**Proposed Temporary Religious Institution (Zen Practice Hall) with Ancillary Shop and Services for a Period of 3 Years in “Industrial (Group D)” Zone, Lot 1633 in D.D. 114 and Adjoining Government Land, Kwun Yam Shan, Yuen Long (Section 16 Planning Application No. A/YL-SK/419)**

**- Further Information No. 1 -**

**- Further Information No. 1 -**

Drg. No. Drain 01

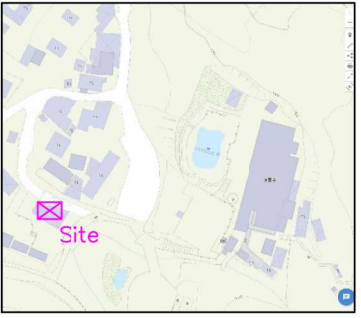
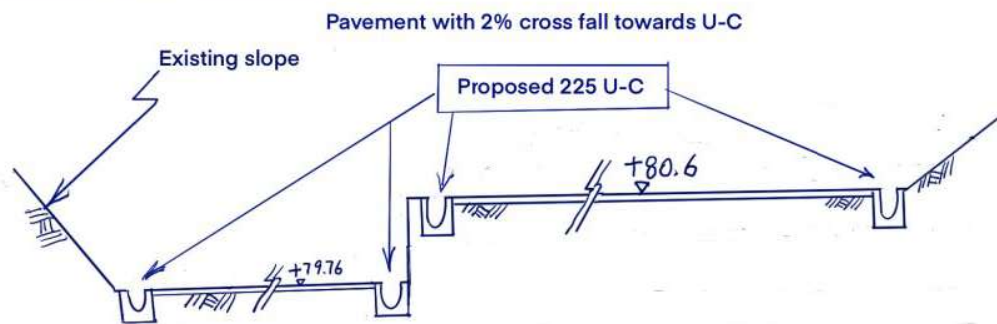
2.3	Please advise the C.L. and I.L size and gradient of the proposed drainage facilities to be discharged from the site and/or the overload flow intercepted from the adjacent lands.	Please refer to Drg. No. Drain 01 of <b>Annex A</b> .

Drg. No. Drain 02

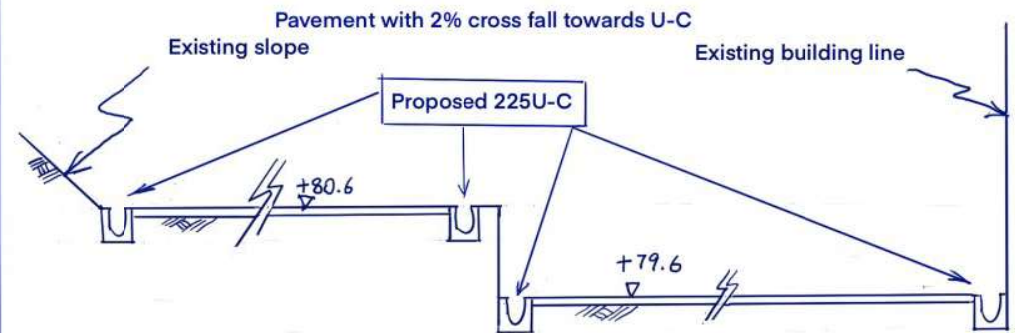
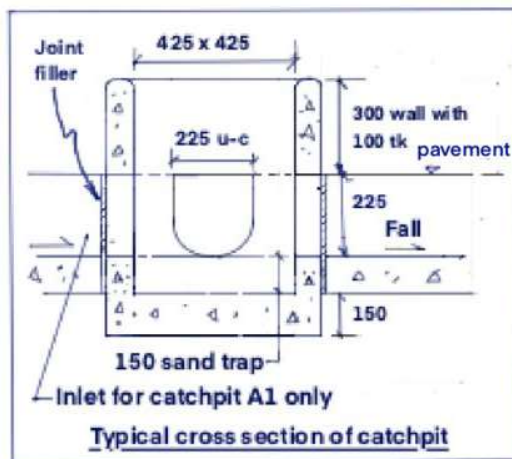
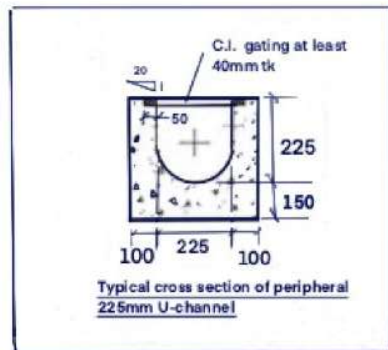
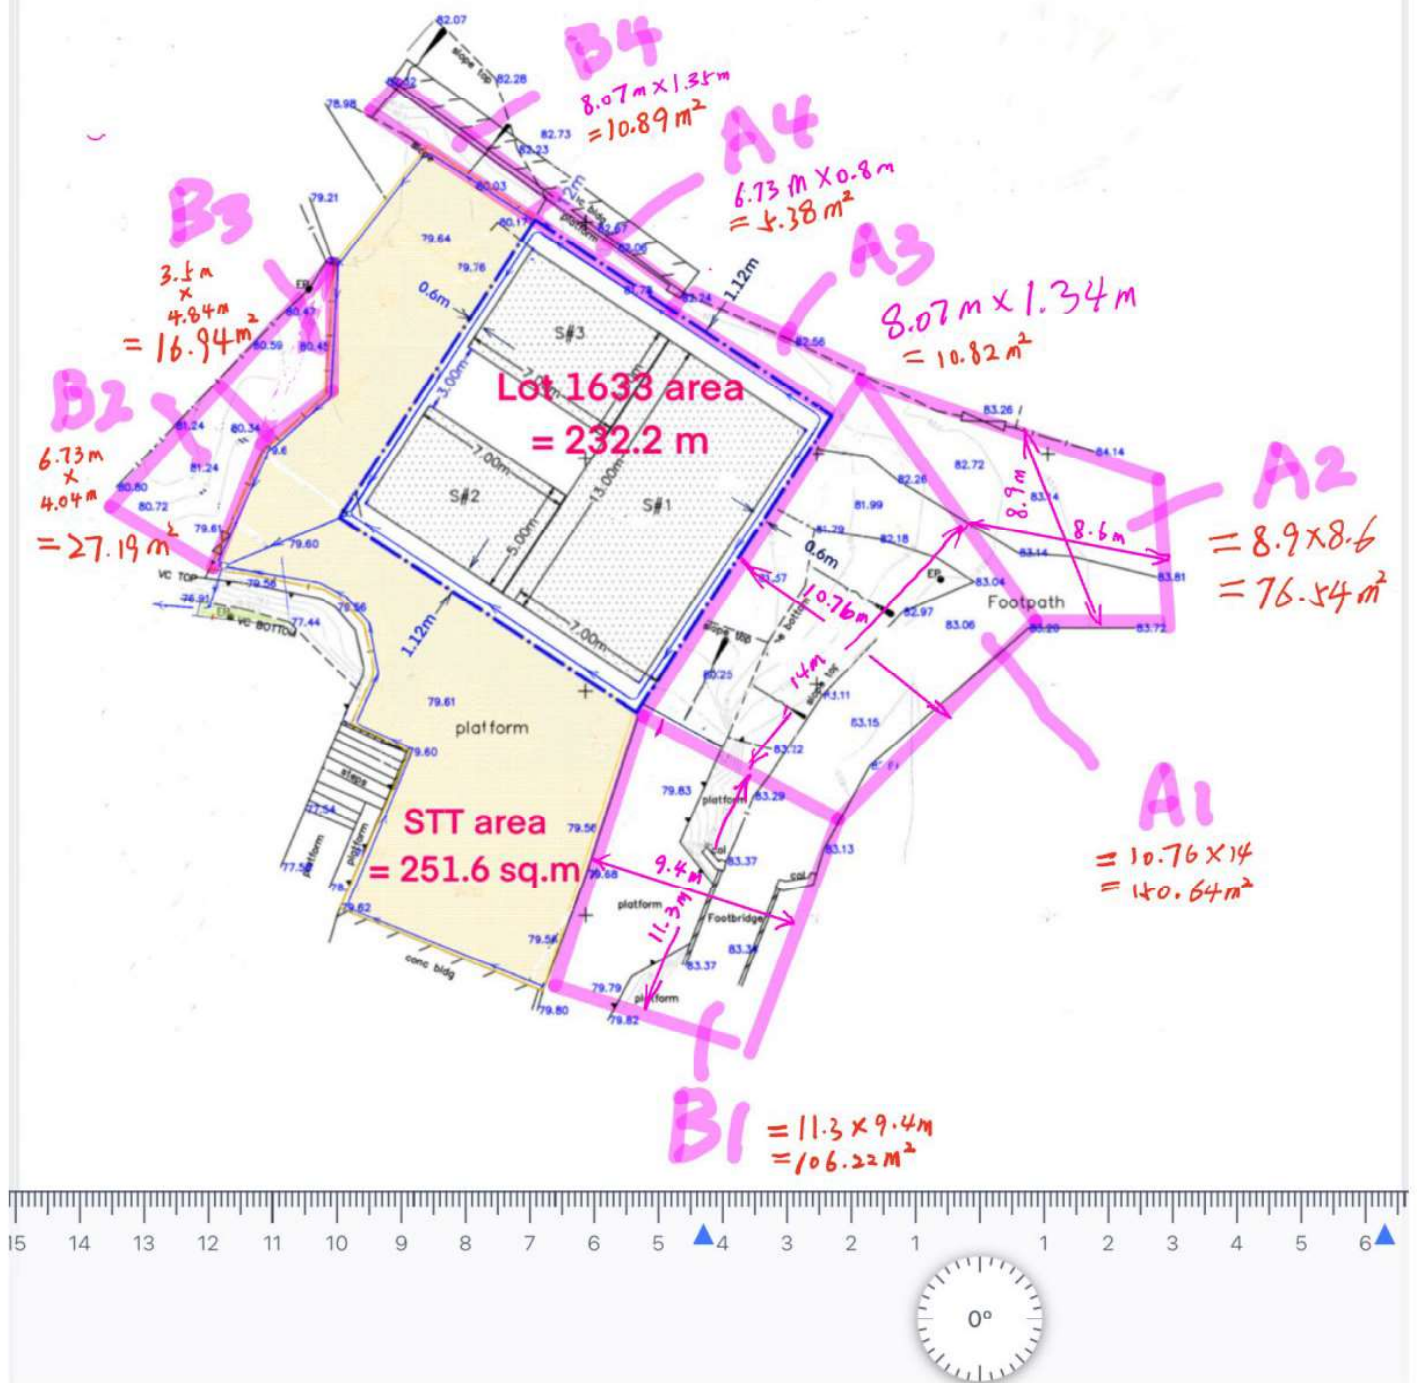
2.5	Cross sections at longitude direction showing the existing and proposed ground levels of the captioned site with respect to the adjacent areas should be given.	Please refer to Drg. No. Drain 02 of <b>Annex A</b> .

2.6	Standard details should be provided to indicate the sectional details of the proposed u-channel and the catachpi.	Please refer to Drg. No. Drain 02 of <b>Annex A</b> .

## Hydraulic calculation

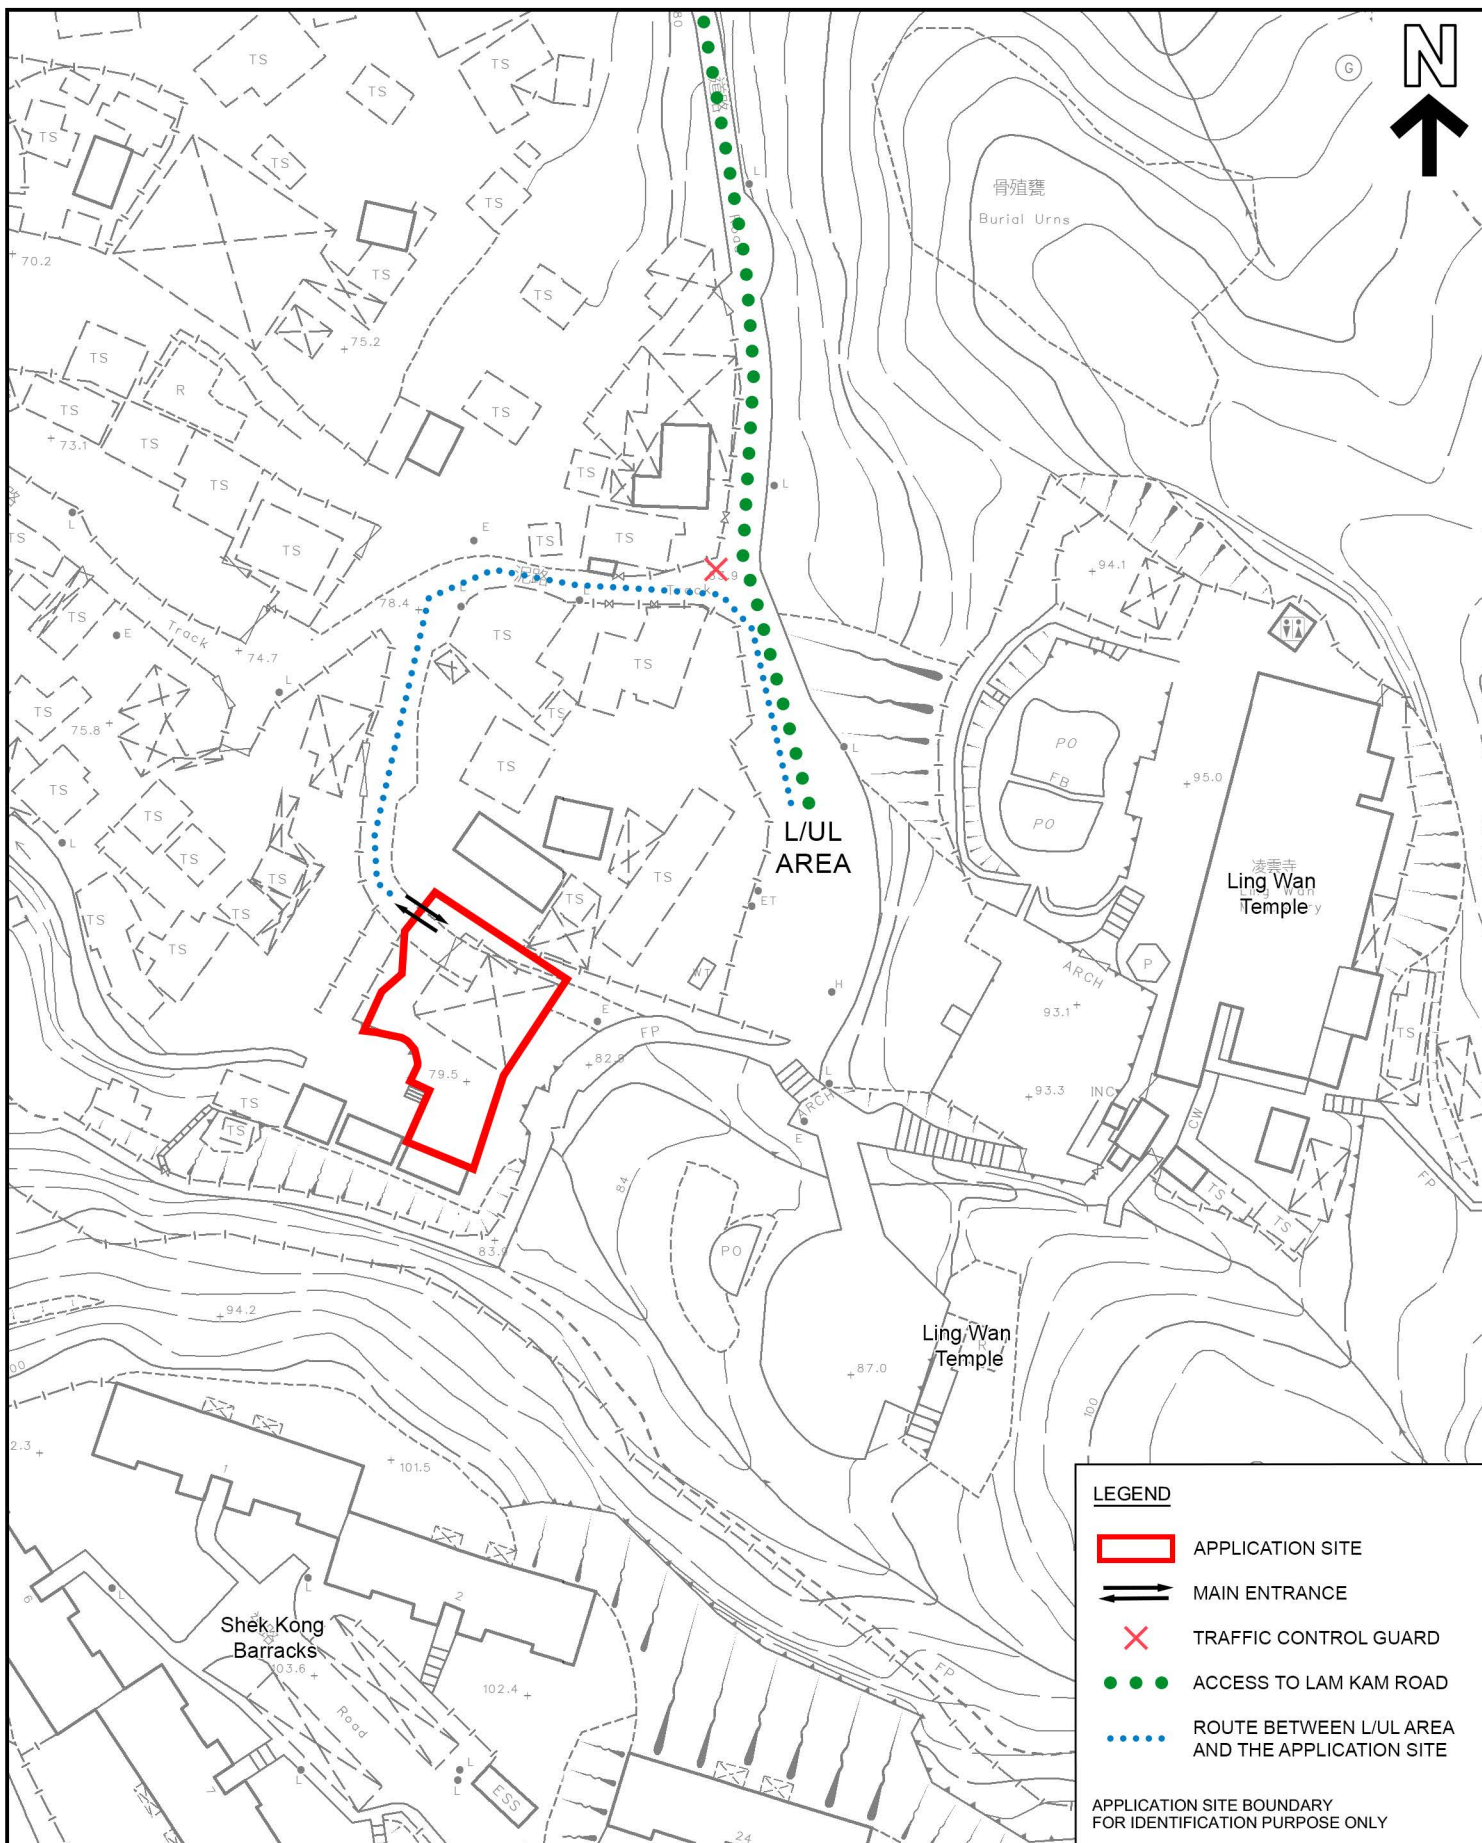
2.4	Please demonstrate with hydraulic calculation that the proposed/existing drainage facilities are adequate to collect, convey and discharge the surface runoff accrued on the application site and the overland flow intercepted from the adjacent lands.	Please refer to the hydraulic calculation of <b>Annex A</b> .

The hydraulic calculation shows that the proposed drainage facilities are adequate enough to discharge the surface runoff from the application site and the adjacent overland areas to the existing open nullah. Therefore, the proposed drainage facilities that to discharge storm water of the 500-year heavy rain return period into the existing drainage facilities under application would be practically implemented.
